THE CITY OF WALTHAM
MASSACHUSETTS
PURCHASING DEPARTMENT

HVAC Renovations for Waltham Public Library, 2024

ADDENDUM NO. 1

February 19, 2024

DRAWN BY: MVM
**ELECTRICAL
 POWER
 ROOF NEW
 WORK PLAN**

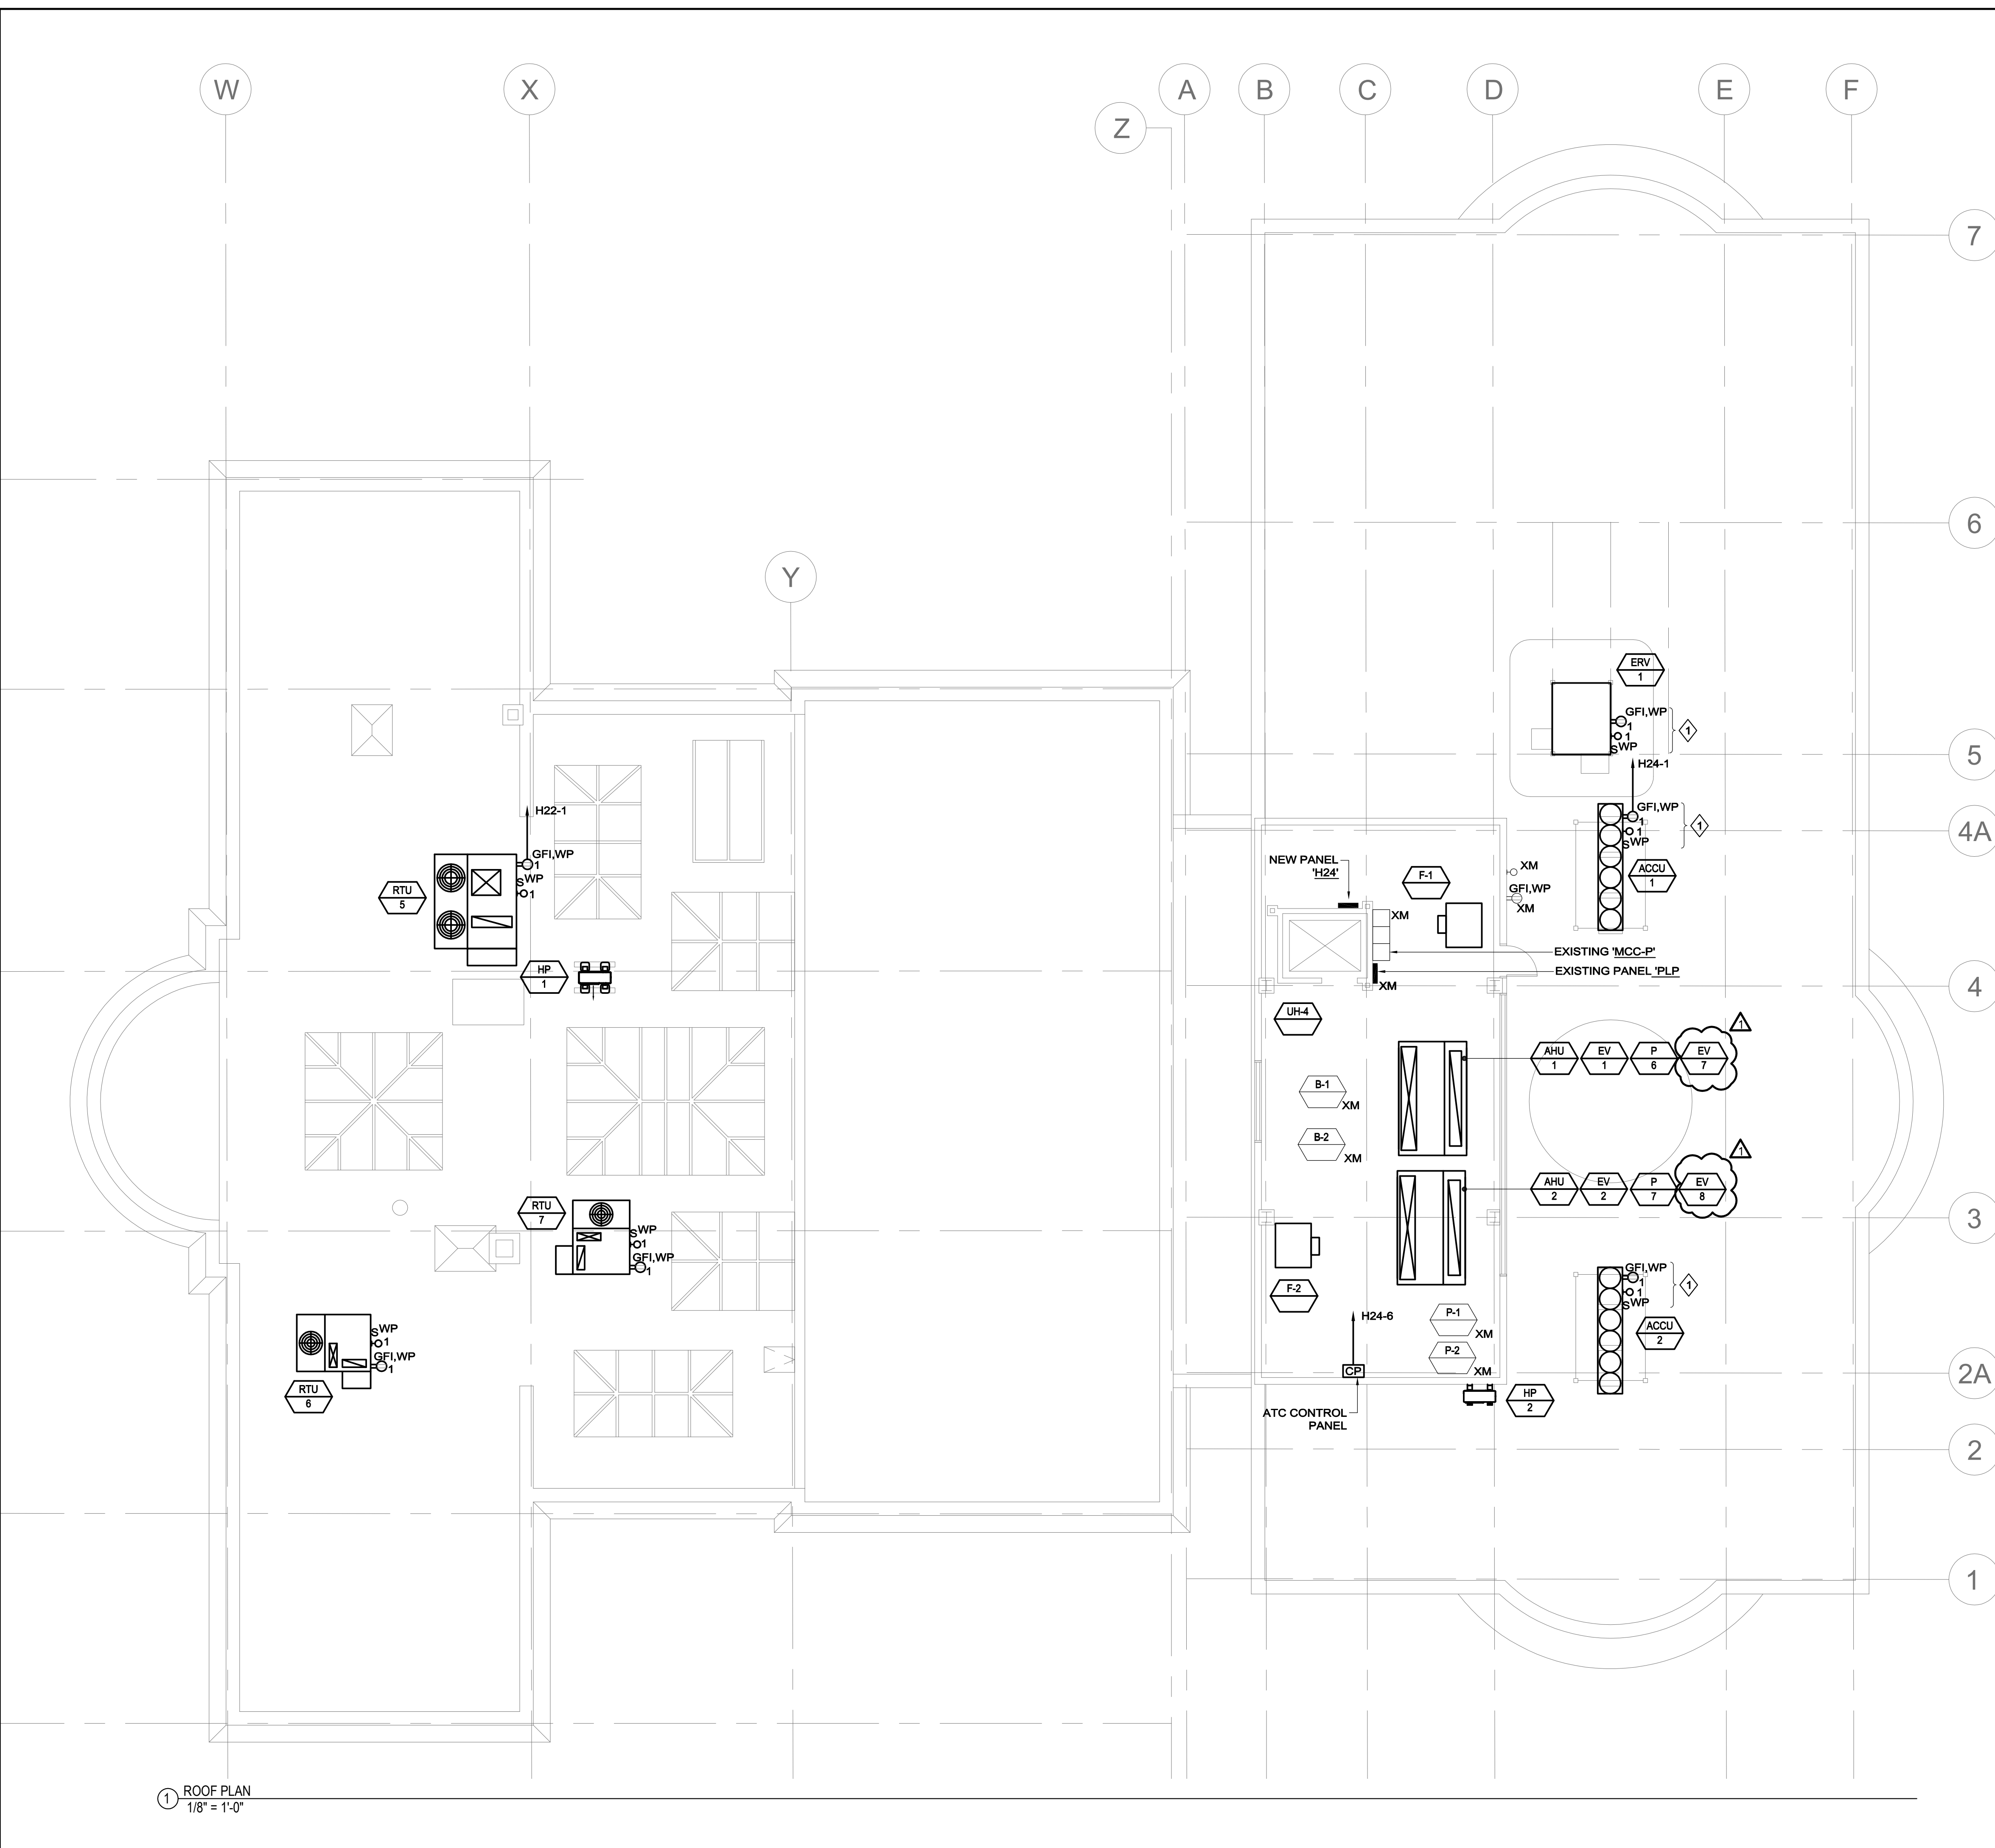
Q5. Drawing E2.4 shows "ACCU-1" & "ACCU-2". I cannot locate these tags on the mechanical equipment schedule on drawing E-9.0. Are they miss labeled? Please confirm what sized circuit is needed for the ACCU's and where the circuit is being fed from.

A5. See Addendum 1

DRAWN BY: MVM
ELECTRICAL ONE-LINE DIAGRAM AND SCHEDULES

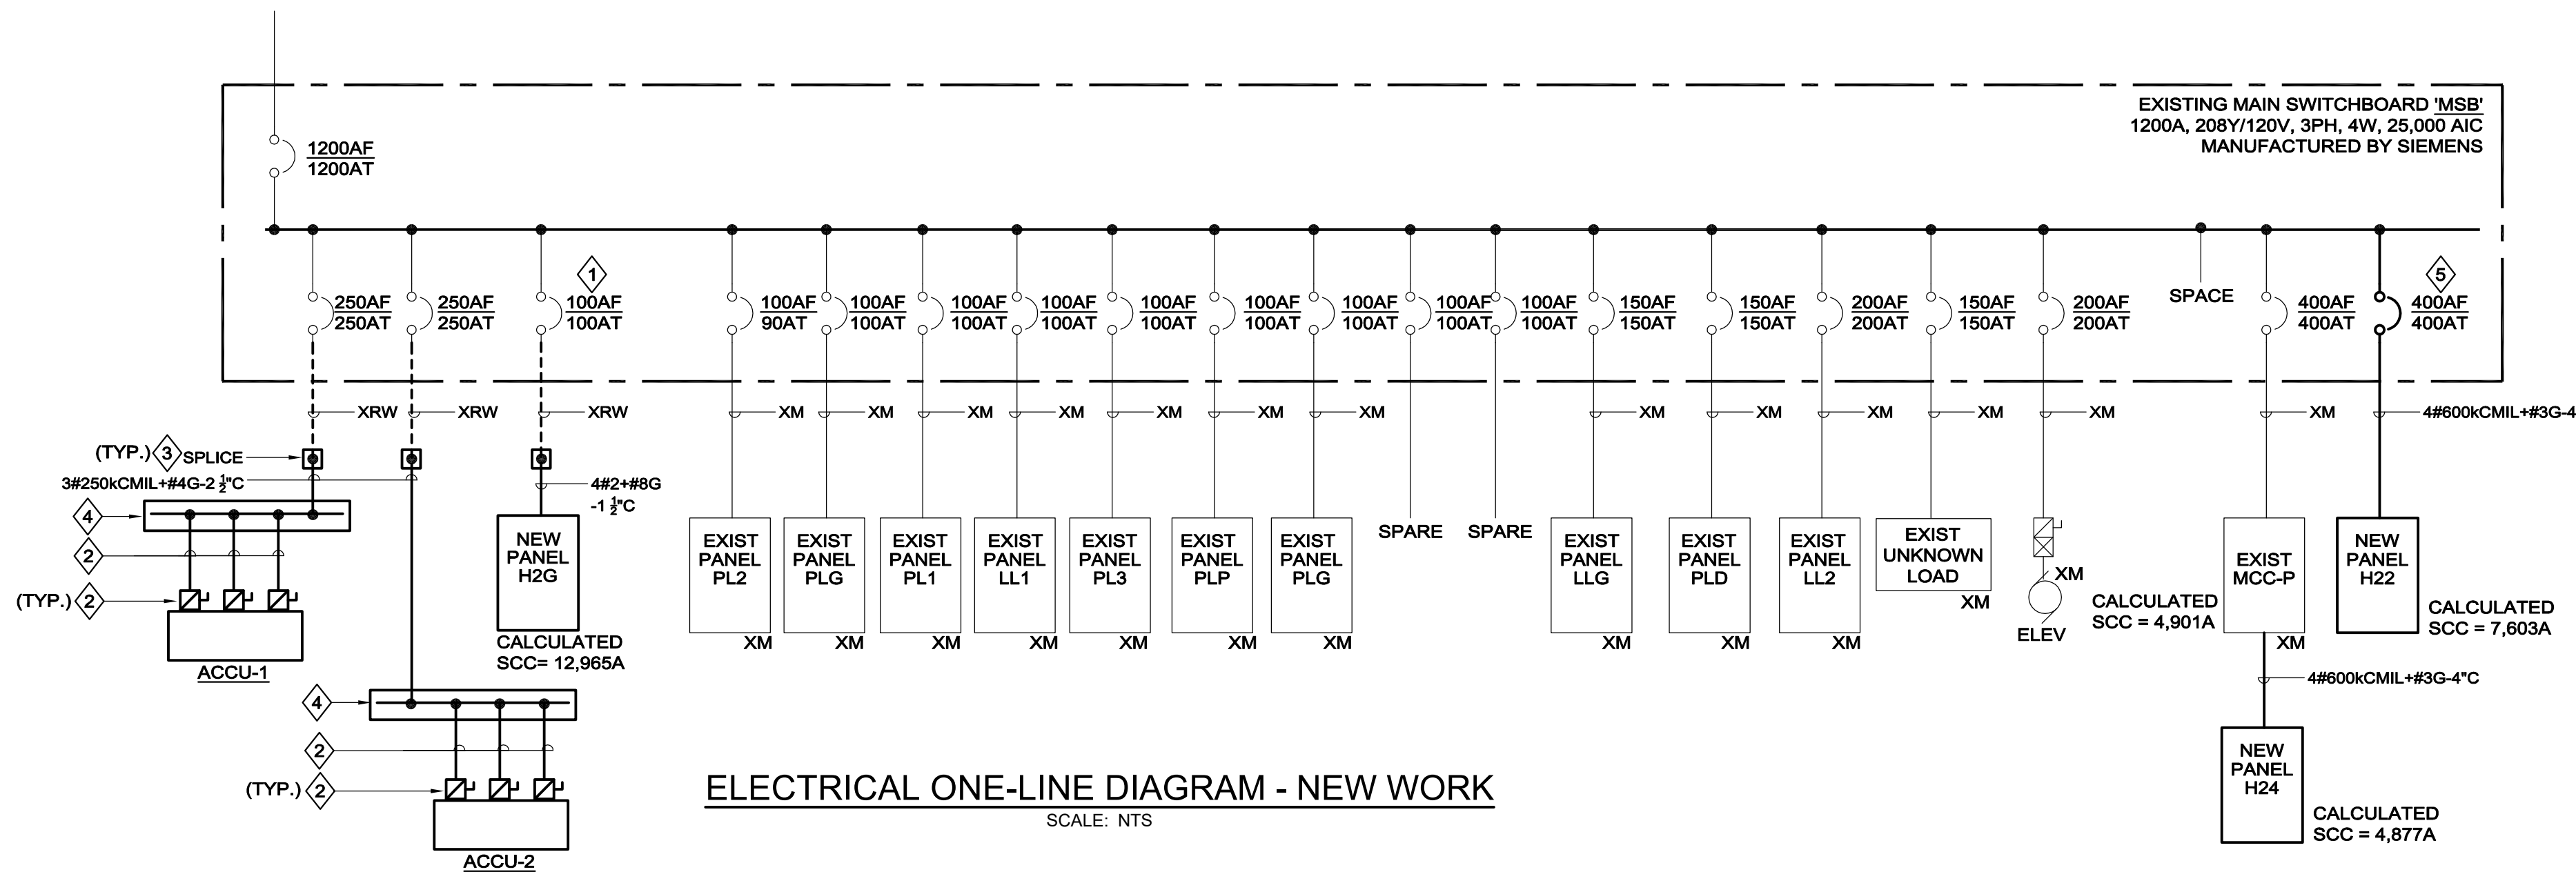
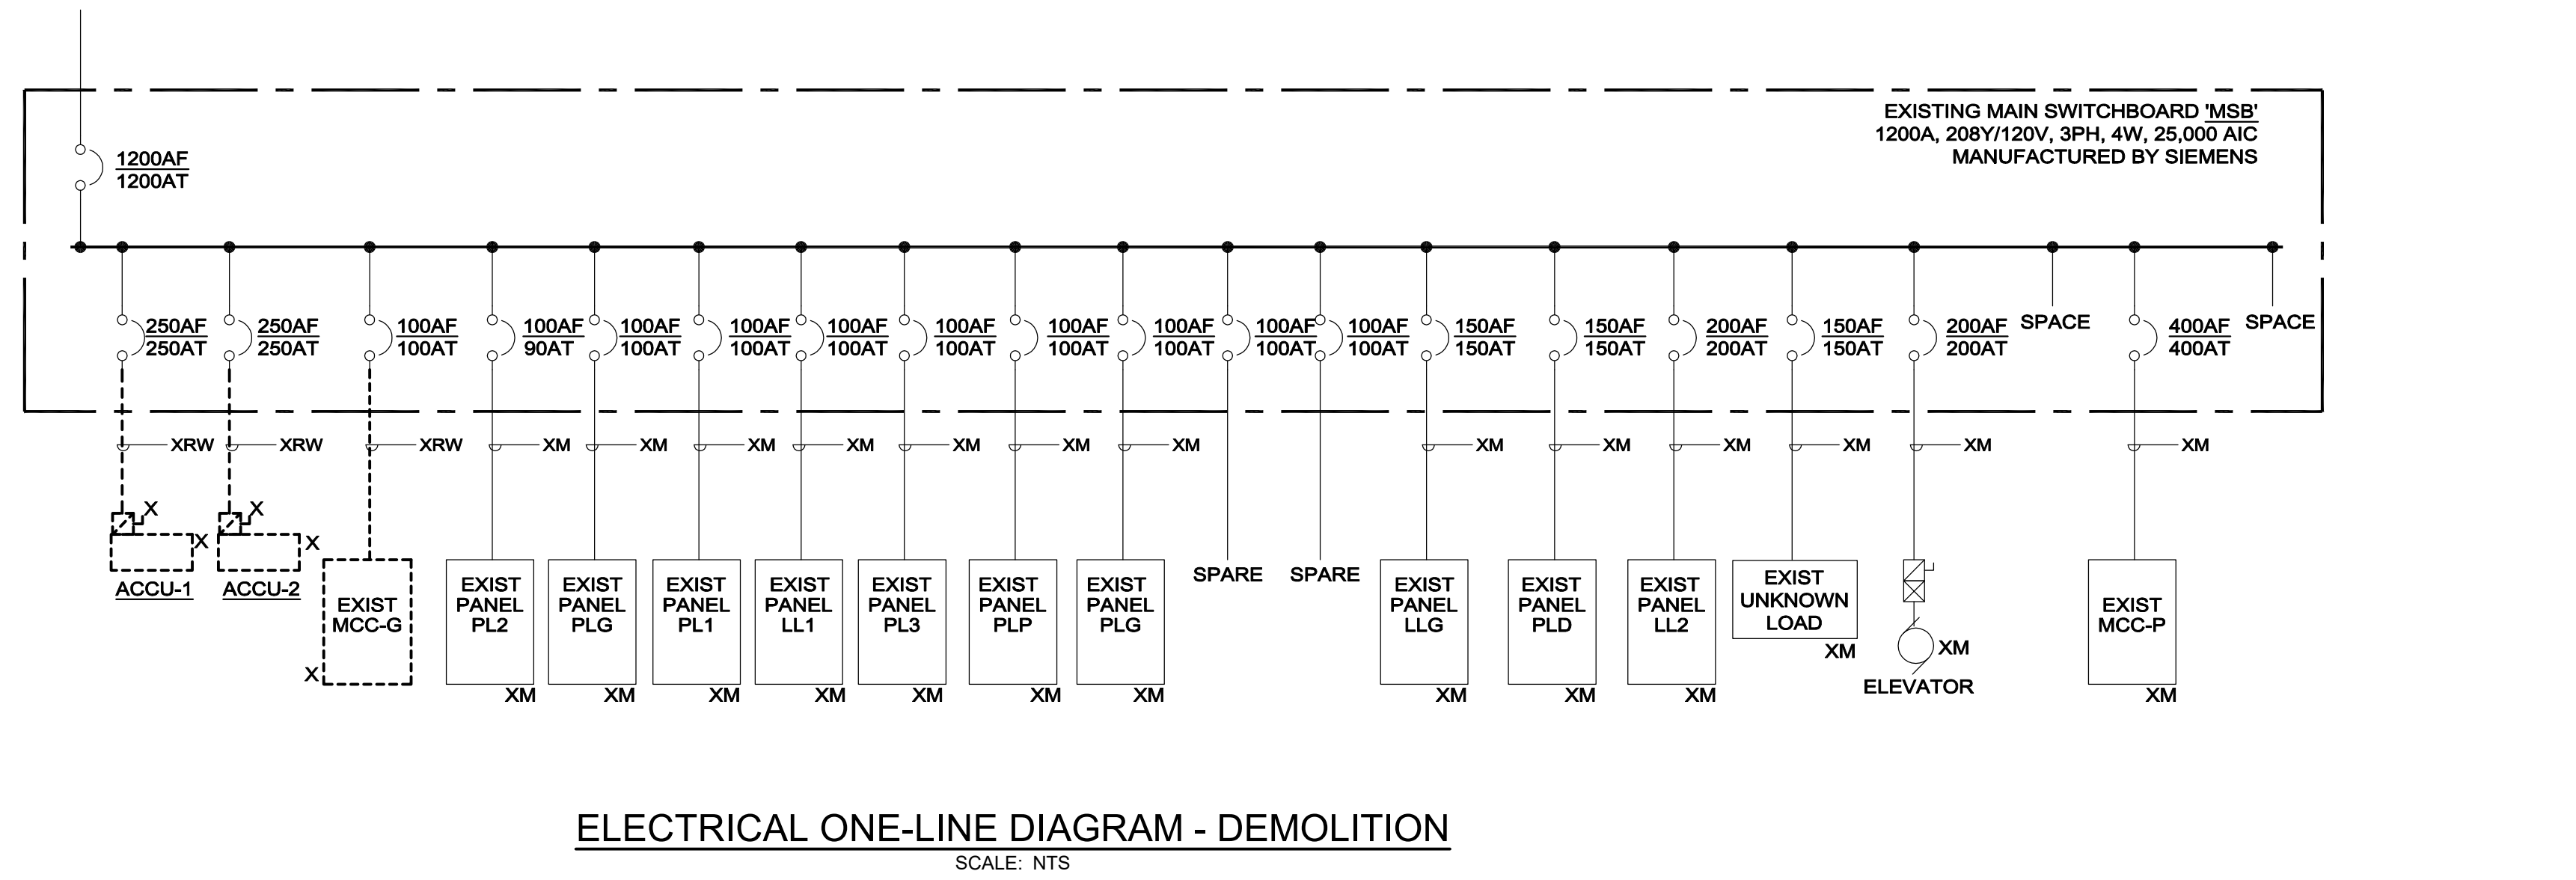
Q3. The electrical riser and panel schedules appear to be missing from the documents.

Q4. For the electrical work, I cannot locate a one-line power riser or panel schedules for new and existing electrical panels. Can these be provided?

Q9. The one-line riser diagram seems to be missing for information regarding the new panels and feeder sizes?

Q10. New panels H2G, H22, H24 do not have panel schedules.

A3. See Addendum 1 drawings E7.0 and E9.1

A4. See Addendum 1 drawings E7.0 and E9.1

A9. See Addendum 1 drawing E7.0 .

A10. See Addendum 1 drawing E9.1
